HISTORIC AND DESIGN REVIEW COMMISSION

January 21, 2015

HDRC CASE NO: 2015-024
ADDRESS: 155 - 161 E COMMERCE ST
LEGAL DESCRIPTION: NCB 106 BLK LOT 32
ZONING: D HS RIO-3
CITY COUNCIL DIST.: 1
LANDMARK: Fishmarket / Sullivan Building / Alamo Savings
APPLICANT: David Lake
OWNER: Chilton Restoration, LLC
TYPE OF WORK: Demolition with conceptual approval of a hotel tower
REQUEST:

WINTER SOLSTICES @ MORNING. Compliant to UDC Section 35-673 - 5.55 Hours of Direct Sun in Box

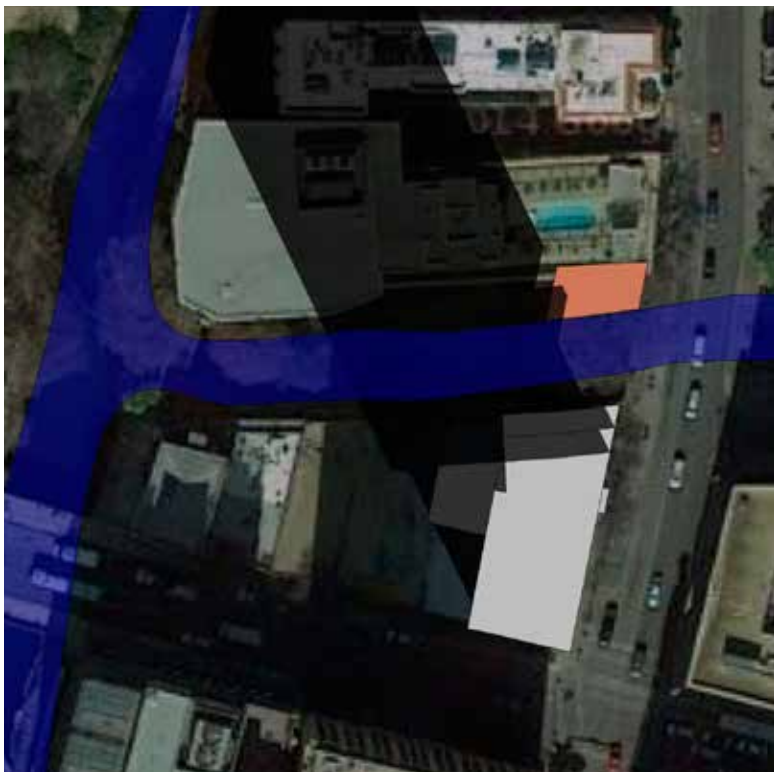
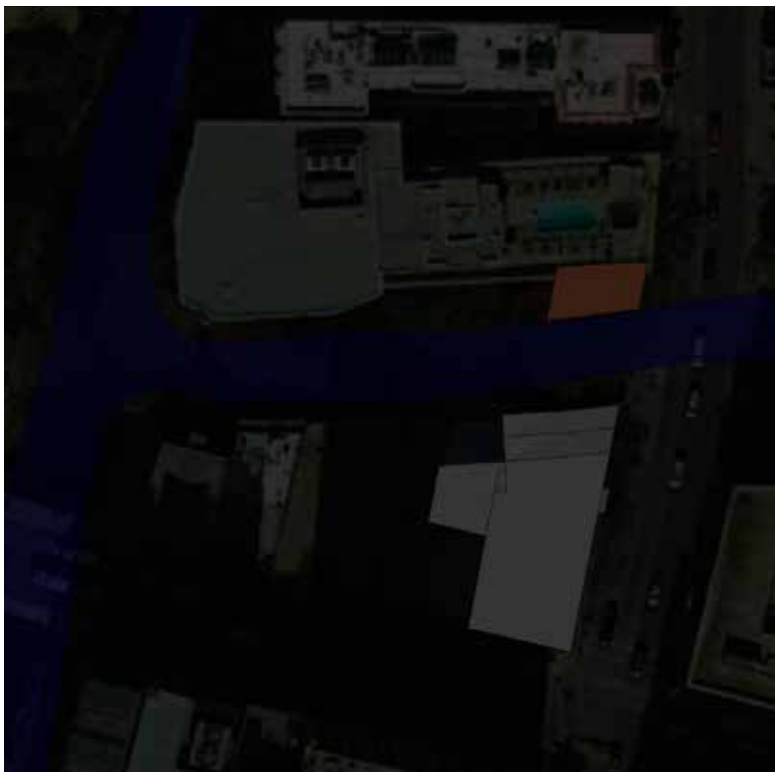
C. The defined area shall receive a minimum of 5.5 hours of direct sunlight, measured at the winter solstice, and 7.5 hours of direct sunlight, measured at the summer solstice.
